February 13, 1987
TS-FC-87-56
LIC-87-056

SUBJECT: Ultrasonic Fuel Inspection in the Spent Fuel Pool

1. INTRODUCTION

FIGURE 1. CROSS-SECTION OF ULTRASONIC TEST RIG

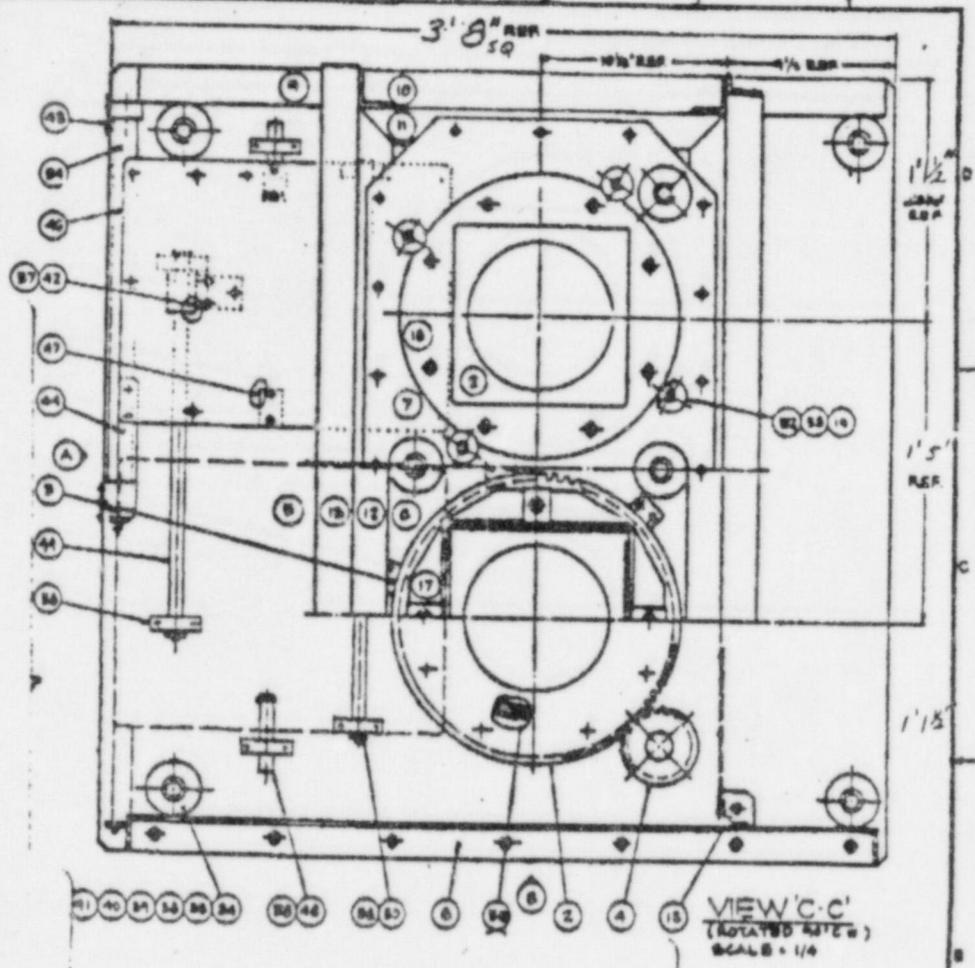
- (1) The independent burnup calculations have been completed, as required above.
- (2) CEA assemblies only are to be moved into Region 2.
- (3) To allow ultrasonic fuel inspection or sipping programs to be implemented, the inspection stand must provide a minimum separation of one foot, five inches (center-to-center) between the fuel assemblies during testing, as specified in the supplementary criticality analysis submitted (letter reference).
